Manuscript ID: egusphere-2024-2525

Original Title: *Improving prediction of particle size with a novel acoustic bedload monitoring system consisting of phased microphone arrays and accelerometer*

Authors: Zheng Chen et al.

Responses to the Comments from Reviewer #1

Figure 6 in *Wyss et al. (2016a)*. Maximum amplitude of a packet $A_{max,p}$ as a function of mean particle-size D_m , for different mean flow velocities V_w

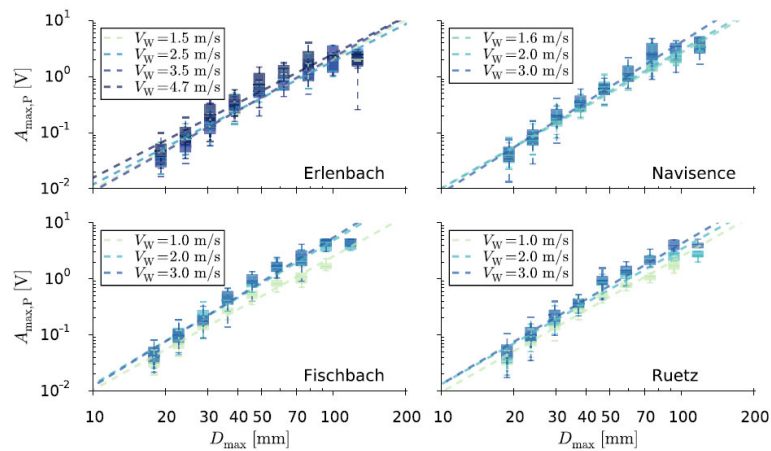
I see a main unknown and potential flaw in the design to relate impact amplitudes with grain size while keeping the drop height for each particle somewhat constant. It is hard for me to imagine how under natural conditions there will be constant drop heights for particles of varying size. Or, the other way around, how would the approach successfully estimate the correct grain size if river bed particles hit the instrument with different fall velocities and overall differing horizontal velocity vectors? What about those particles that rather slide and roll instead of jumping? These fundamental questions are neither raised nor implicitly addressed by the study, neither in the experiment design nor in the argumentation.

First, the approach of establishing a correlation between the impact signal amplitude and the particle size is widely used and physically grounded in bedload surrogate sensing. This relationship has been demonstrated by many previous studies, including *Wyss et al. (2016a)* and *Mao et al. (2018)*, where larger particles typically generate higher signal amplitudes due to their greater momentum and impact energy. Our results are consistent with this expectation.

Second, we have indeed explored the role of impact velocity in our experiments. Although impact velocity does affect the signal amplitude, our laboratory tests show that its influence is less significant than that of particle size. Similar conclusions were reported by *Wyss et al. (2016a, WRR)*, who demonstrated that increases in flow velocity (and thus increasing particle impact velocity) led to only modest increases in signal amplitude of the SPG system across particle sizes (see Figure 6 from *Wyss et al. (2016a)*, attached below for reference).

In our experiments, we controlled the **drop height based on the particle's center of mass**, resulting in slightly different release heights for particles of different sizes. This design choice was not intended to mimic any specific natural condition, but rather to ensure consistency with previous laboratory calibration studies of SPG systems (*Chen et al.*, 2022, JHR), allowing meaningful comparisons to be made across technologies. Moreover, under a fixed center-of-mass drop height, smaller particles do indeed reach slightly higher impact velocities than larger particles. This matches the common trend observed in natural settings whereby smaller bedload particles tend to move faster than larger ones under the same flow and bedload slope conditions. We have added a note to the manuscript to clarify this point.

Figure 12 in Wyss *et al.*, (2016, JHE). z_p ratio of the left and the right central geophone plates (gP_{left} and gP_{right}) as a function of unit bed load transport rate

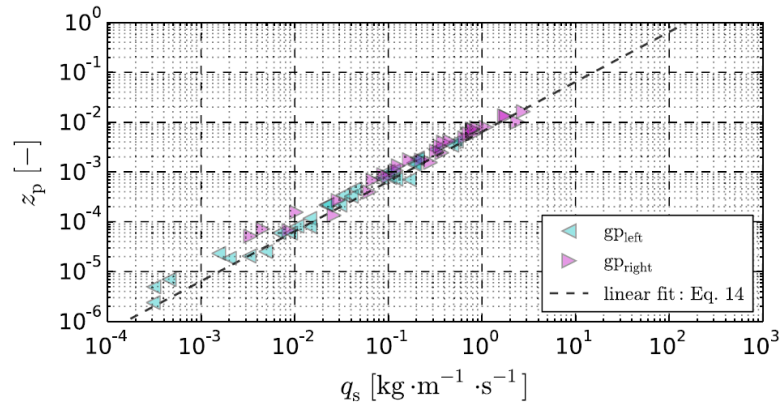
- **General comment 3:** Another, major flaw arises from the inability to locate and quantify the effects of multiple particles being in contact with the plate. As nice as it is to isolate single impacts, under natural conditions the norm will be to experience multiple impacts during a bedload transport period, even during the time window for which the first pulse of an impact signal is collected. If it is impossible to reliably locate two or more sources at a time, it will also be impossible to extract reliable information on the particle size and hence the envisioned total bedload flux across the sensor plate. I might have missed some detail in reading the manuscript but from the results section (e.g. Fig. 7) it seems that the two synchronous impacts cannot be deciphered, as one would expect from the capabilities of a phased array setup, and as is discussed in the manuscript further down.

We acknowledge the reviewer's concern regarding the possible occurrence of *multiple simultaneous impacts under natural conditions*. Previous work by Wyss *et al.* (2016, JHE) quantified the probability of overlapping impact signals using the time ratio z_p . Their analysis (Fig. 12, also presented below for reference) showed that for transport rates q_s smaller than ~ 5 kg/s/m, z_p values are typically below 1, indicating that simultaneous impacts are unlikely and single-particle signals can be reliably isolated. Only for intensive transport rates, such as those exceeding ~ 100 kg/s/m reported for the Erlenbach site (Hegg and Rickenmann, 1999), the value of z_p is expected to be close to 1, in which case the number of identified packets from the geophone signal may not deliver accurate measurements.

Figure 4(d) in the main text. Illustration of the first wave of the microphone signal.

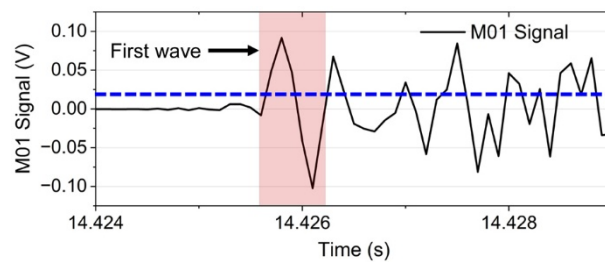
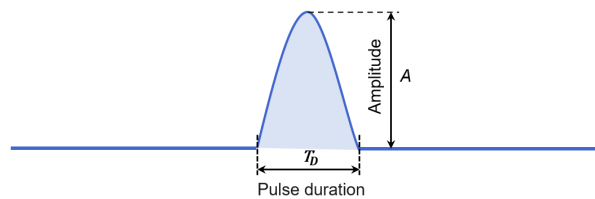
We hope this revised presentation better contextualizes the design rationale without overloading the section with technical derivations (lines 223–231).
 - **Specific comment 13:** l. 213, why a sine wave and not the more likely to expect pulse signal? Can you explain/justify this? Will this decision not affect the validity of the test outputs with respect to the envisioned natural settings?

We appreciate the reviewer's thoughtful question regarding the choice of input waveform in the numerical tests. The use of a periodic cosine (or sine) wave was a deliberate decision based on both practical and physical considerations.

Second, the sine waveform is also physically justifiable. Impact-induced acoustic signals recorded in our laboratory experiments often exhibit an initial phase of high-frequency oscillation that closely resembles a few cycles of waveform. As shown in Fig. 4d, the impact-induced signals recorded by a microphone element in our laboratory display an initial phase of rapid oscillation lasting 1–3 ms. These oscillations result from the short-duration contact between the particle and plate and are affected by particle size, contact stiffness, and impact dynamics. Similar behaviors have been reported in SPG system data and in finite element simulations (*Chen et al.*, 2022 <https://doi.org/10.1080/00221686.2022.2059585>), supporting the physical relevance of our waveform choice.

Furthermore, the half-sine pulse is widely recognized as a classical form of mechanical shock loading in standards such as IEC 60068-2-27. Our use of a short-duration periodic cosine wave can be seen as an idealized extension of this fundamental pulse type for the purpose of numerical analysis.

We agree that an impulse-type input could also be used in such simulations, and it may better reflect certain broadband aspects of real-world signals. However, we believe this difference in source waveform has limited impact on the key findings of this study, which primarily focus on the system's ability to localize and reconstruct acoustic sources using beamforming principles. Most importantly, the PMA system is not solely evaluated based on simulations—its performance is being validated through extensive physical tests, including controlled drop experiments and future flume and field applications, which will incorporate the full complexity of natural impact signals.
